Office Action Summary	Application No. 10/771,289	Applicant(s) MEZIERE ET AL.	
	Examiner Leslie R. Deak	Art Unit 3761

DETAILED ACTION

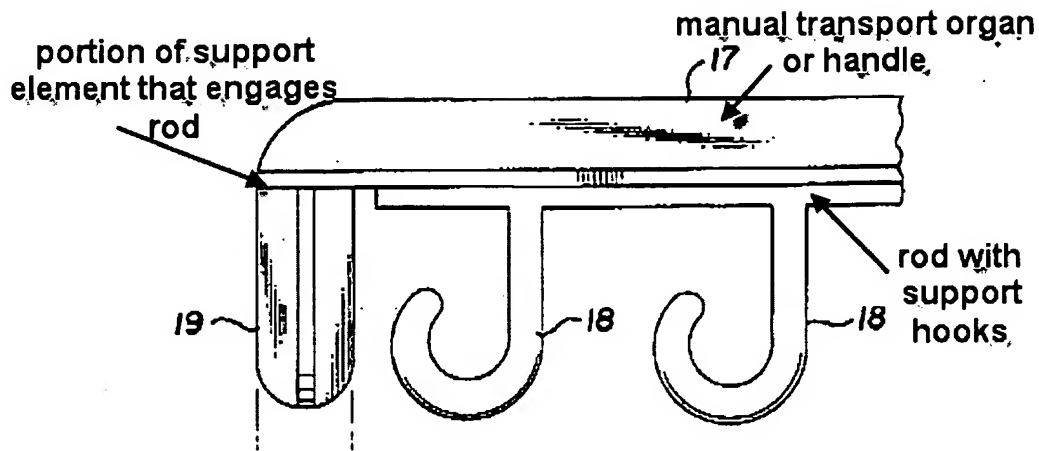
With regard to claims 8-13, 24, the support elements comprise a body or rod that carries a top section that may be used as a manual transport organ or handle to rotate the support elements or arms. The body or rod further comprises hooks 18 and is connected to the support element. See Belokin FIG2, as annotated by the Examiner, below.
